ISSUE NO. : 10-006	DATE : 15th Mar. 2010	PAGES : 1 OF 1
--------------------	-----------------------	----------------

SUBJECT	Modification of Engine Earth Lead Wire
MODEL	GT650, ST7
EFFECTIVE F/M NO

This service bulletin is written to announce a modification of Engine Earth Lead Wire

<BEFORE : CLUTCH COVER - M6 BOLT >

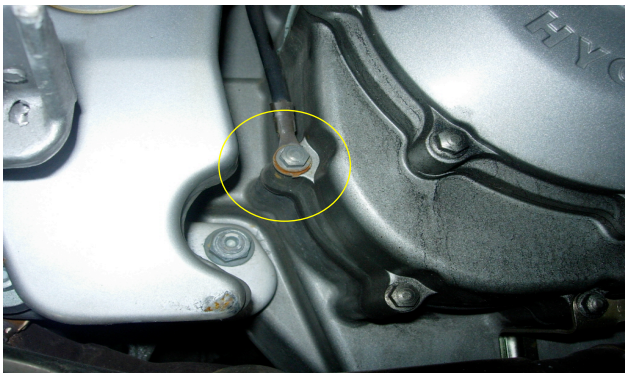
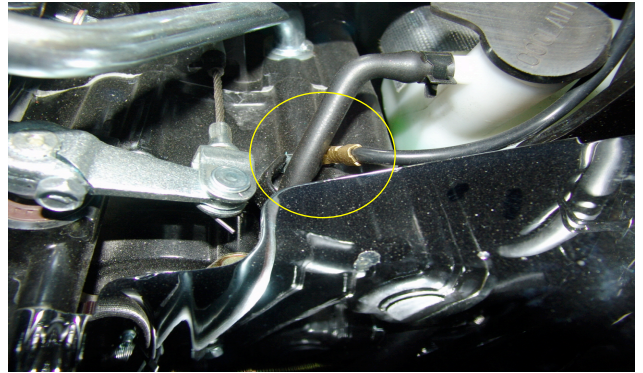
- 1) Engine earth of wiring harness is connected to assembly bolt of painted Clutch cover.
The painted clutch cover makes high resistance and sometimes wiring harness is melted by high resistance.

- 1) The connection point of harness has been changed.
- 2) We put masking tape round the bolt connection point while painting the crank case.

<AFTER : CRANK CASE, LH - M6 BOLT >
